AGNICO EAGLE

Re: Response to 2AM-DOH1335 Water Licence Amendment – Operational Update – Technical Comments

Interested Party:	KitIA	Rec No.:	KitIA-NWB-01
Re:	Hope Bay Operational Update Scope Activities

2026 Water License		
Doris Area Summary		
DATE: May 2026	APPROVED: -	FIGURE: 1

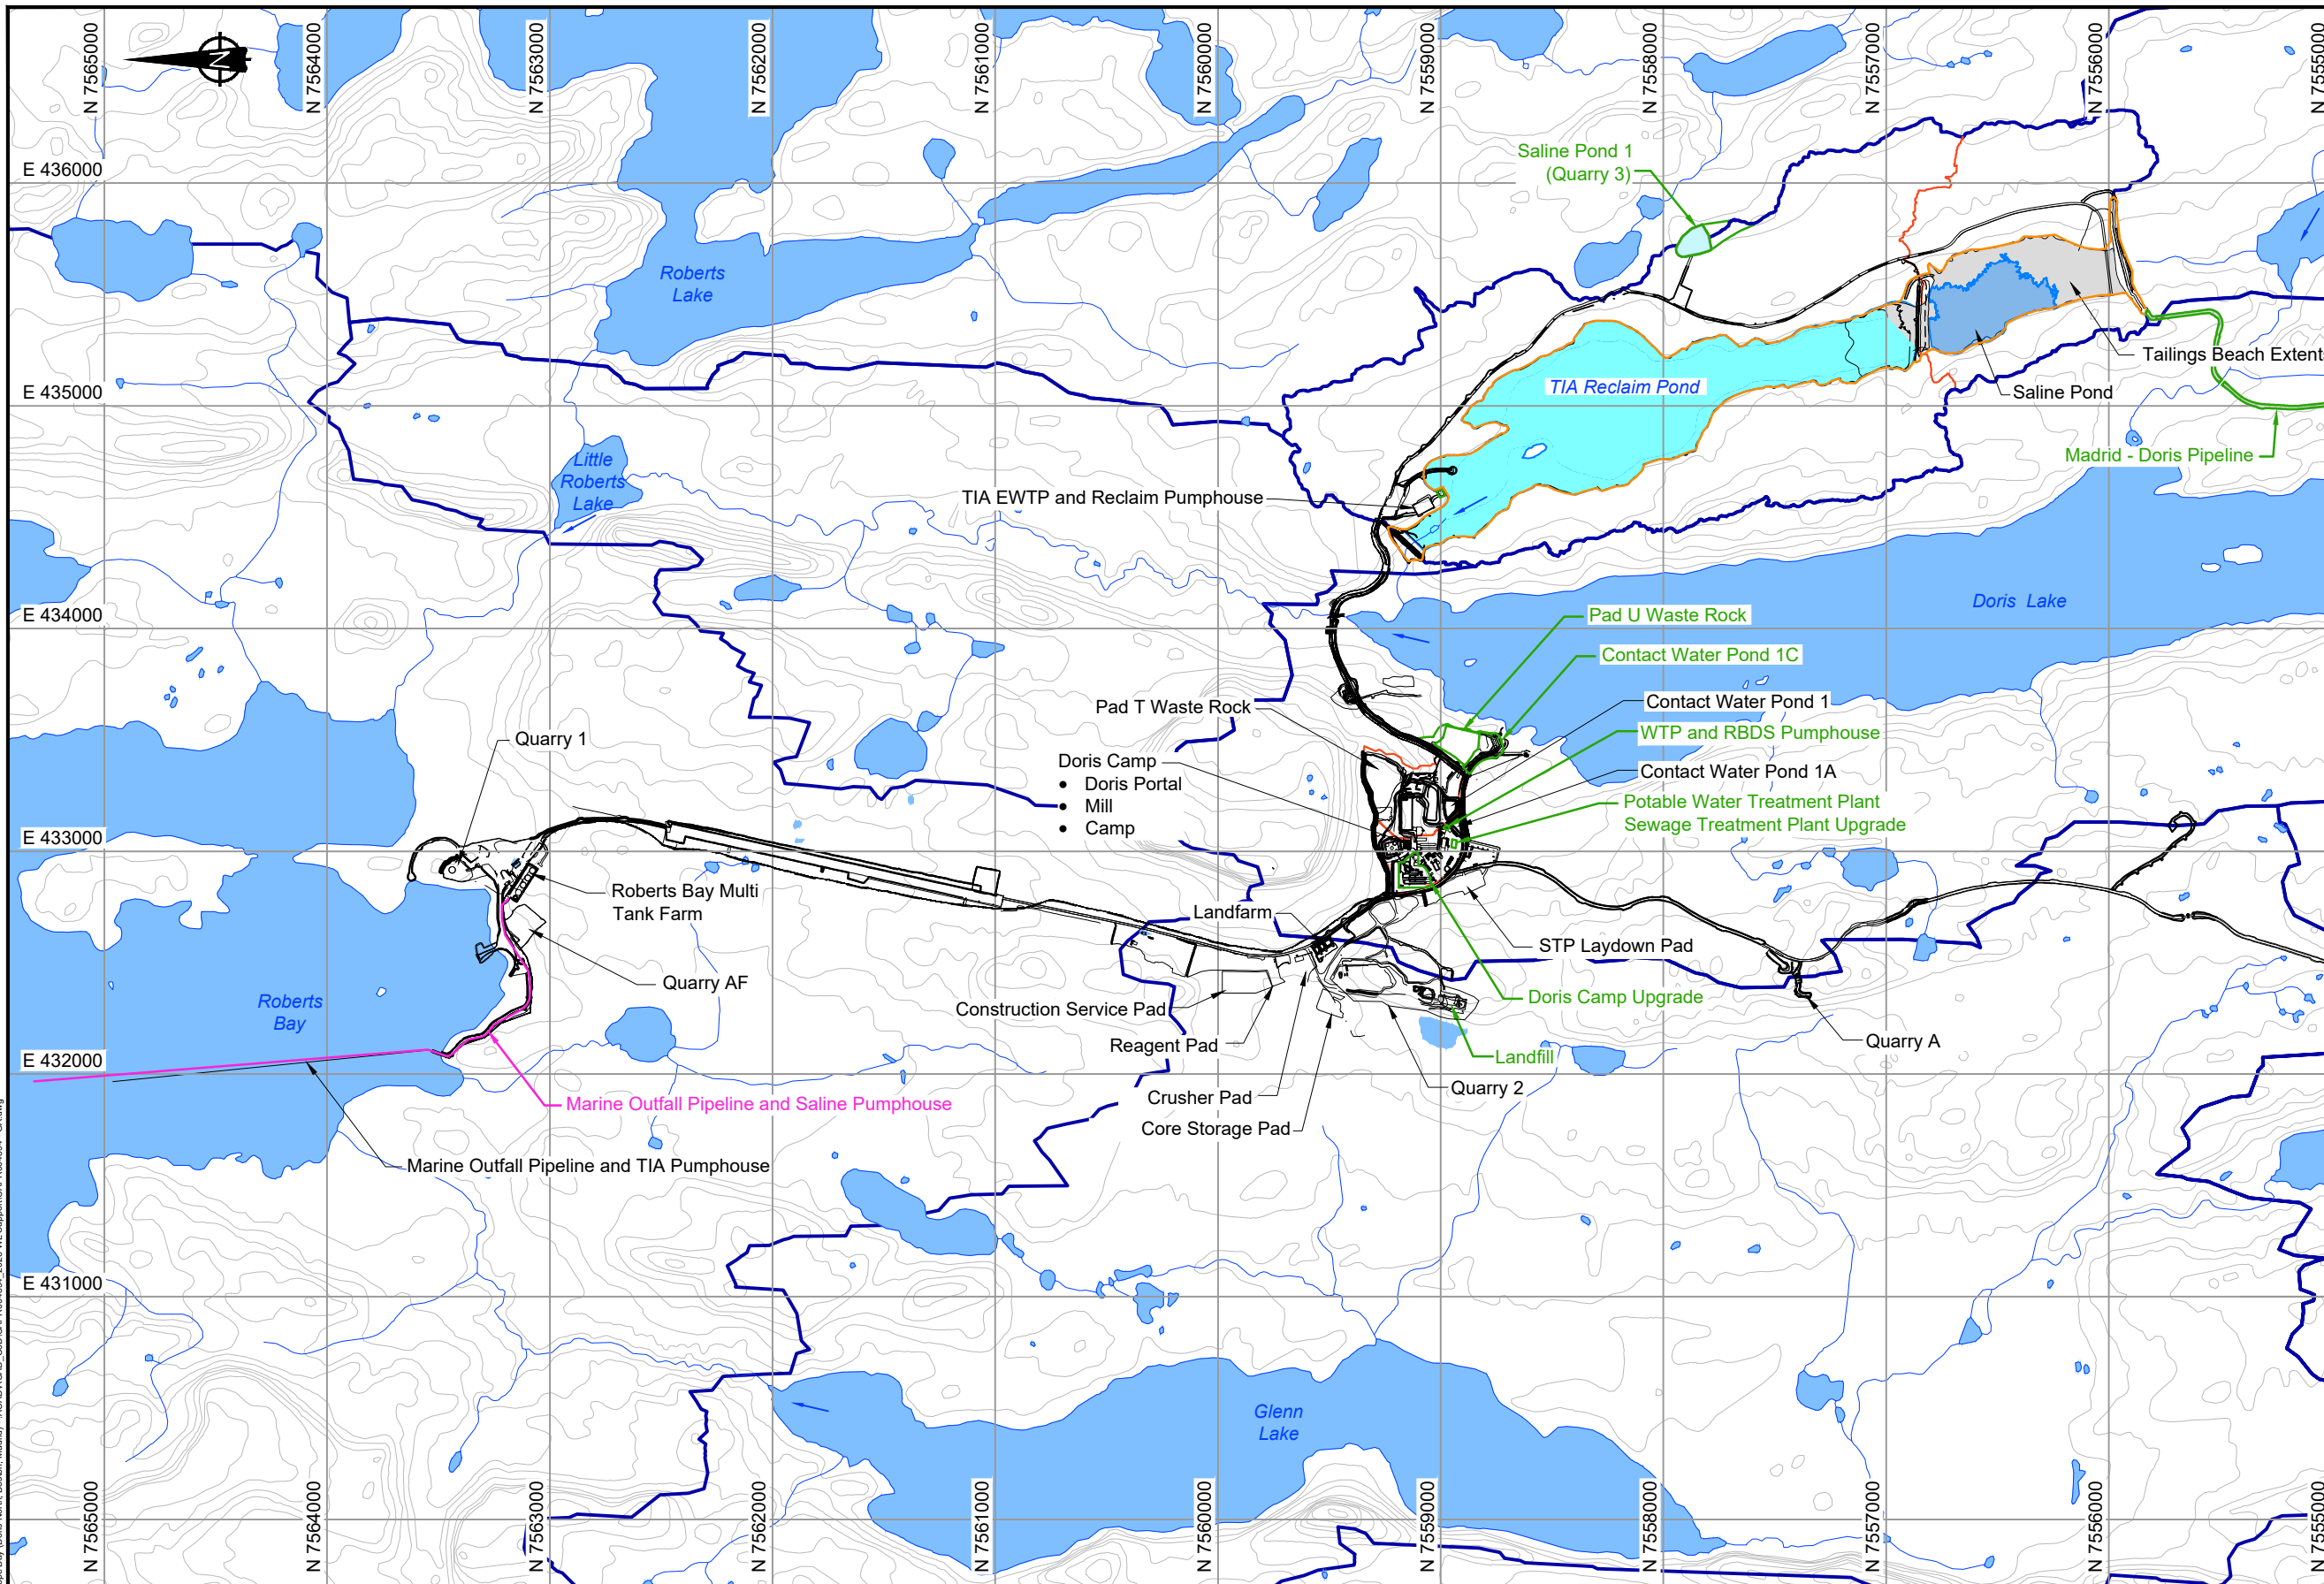
- *Please add a caption and figure number (assume Figure 1.1-3) to the maps on pages 7-10.*
- *Please provide the location of the proposed infrastructure within the purple polygons on the map for clarity.*

To address the KitIA’s comment of proposed locations, Agnico Eagle has provided the following maps to present existing infrastructure, approved but not constructed infrastructure, and the preliminary 2026 proposed additions for the Doris Area (Figure 1) and Madrid - Patch Area (Figure 2). We reiterate that, consistent with Water Licence requirements, detailed design information will be developed through the engineering process and submitted to the NWB for review and approval prior to construction, which will include infrastructure location specifics.

Interested Party:	ECCC	Rec No.:	ECCC-TRC-01
Re:	Dust-Related Impacts to Water Quality

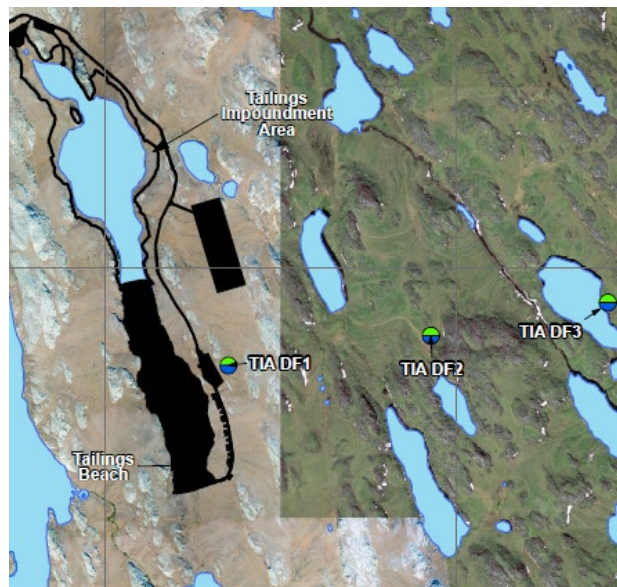
1. *Discuss the direction dust from the dry stack would be expected to disperse, including predictions for dispersion distance from the facility;*
2. *Discuss planned measures to mitigate and monitor for dust and snowpack deposition related impacts on water bodies from the dry stack tailings. This should be outlined in an existing monitoring and management plan or a new plan prior to transition to dry stack; and*
3. *Discuss planned monitoring in advance of implementation of the dry stack configuration to characterize existing dust/snow conditions in the absence of the dry stack tailings facility.*

It should be noted that dust monitoring is captured under Project Certificate No. 009. Term and Condition No. 1. To address this comment, Agnico Eagle have three established dust monitoring stations as presented in the image below (Air Quality Management Plan, Figure A.2) to the east of the Tailings Impoundment Area. As outlined in the Atmospheric Compliance Monitoring Program Report (submitted with NIRB Annual Report; ID: 361093), prevailing winds at Hope Bay are predominately from the west.

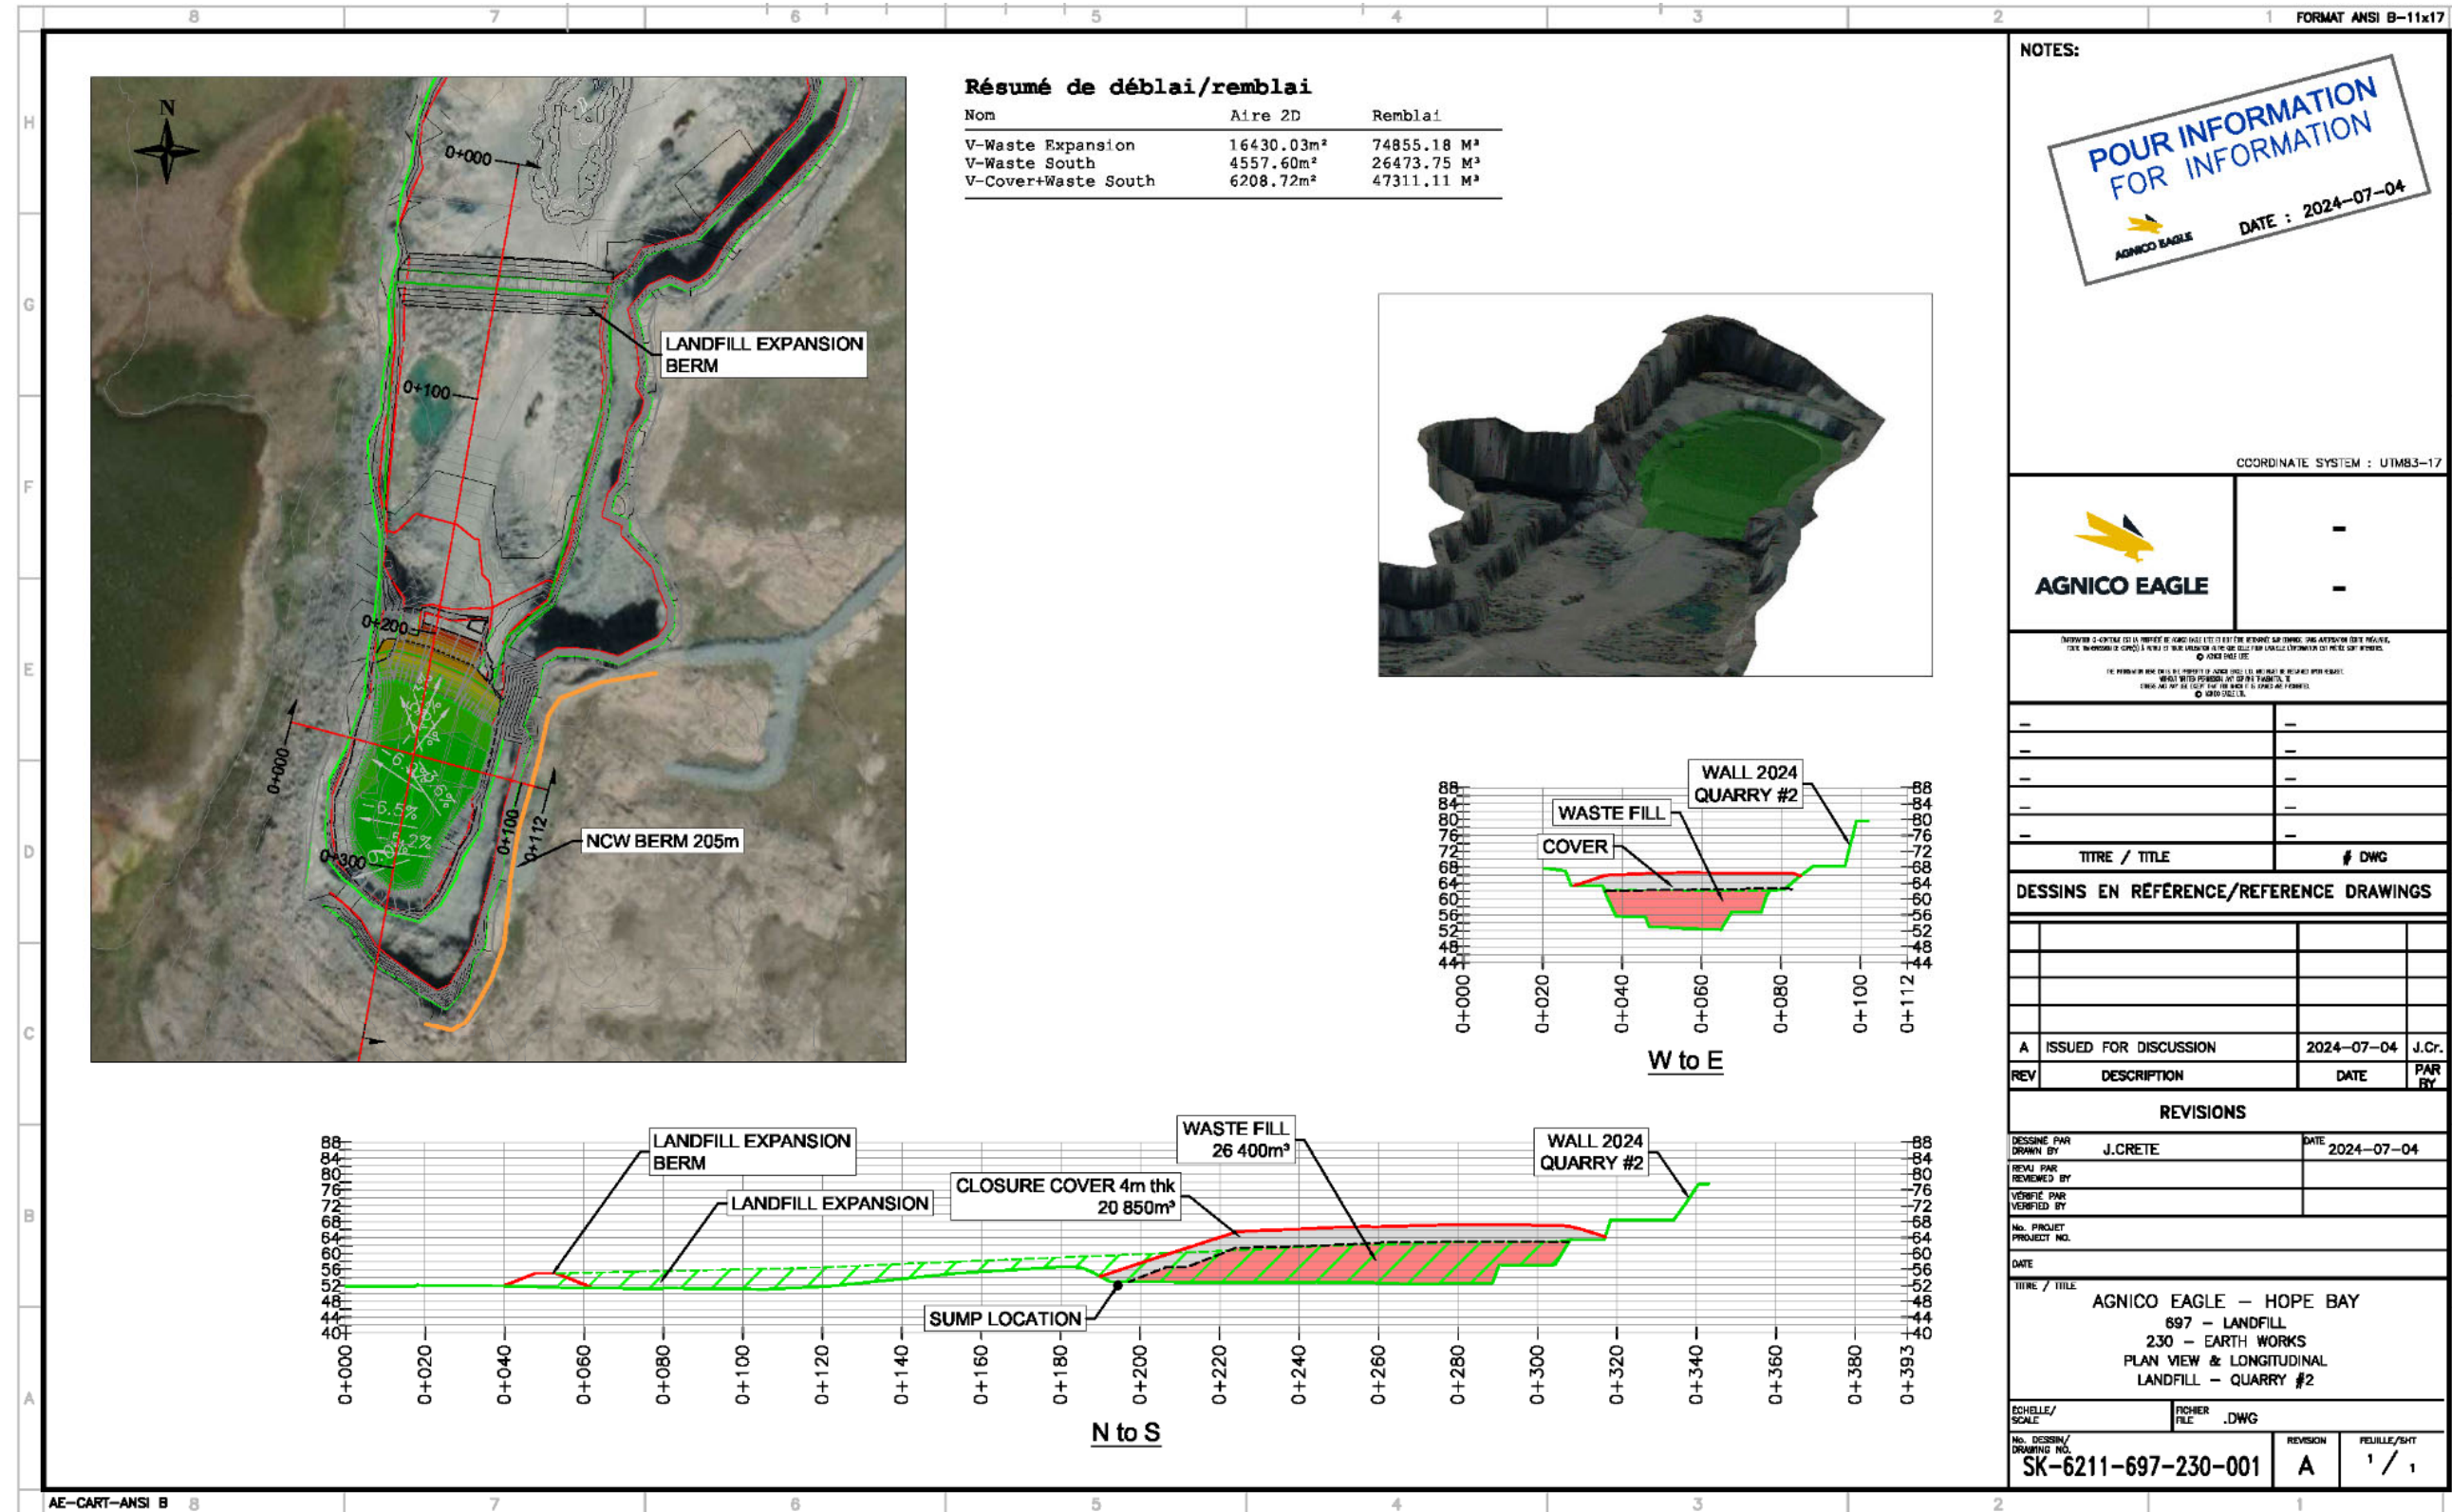
IR-08a) CIRNAC recommends the Applicant provide an outline of the drainage basin and drainage patterns within the RPA.

IR-08b) CIRNAC recommends the Applicant provide an outline of the drainage basin and drainage patterns within the LPA, including the existing and proposed water management infrastructure.

IR-08c) CIRNAC recommends the Applicant provide a detailed depiction of the drainage patterns within the solid waste disposal area(s).

As noted in the April 24, 2026 response, Quarry 2 and the waste management infrastructure within the Quarry are previously approved infrastructure that have gone through the appropriate review process; this includes the landfill. Agnico Eagle is providing Figure 5-2 from the Non-hazardous Waste Management Plan (January 2025) showing the location of the landfill in Quarry 2, plan view and design details. The landfill was approved on April 25, 2025 (417 days ago as of June 16, 2026).
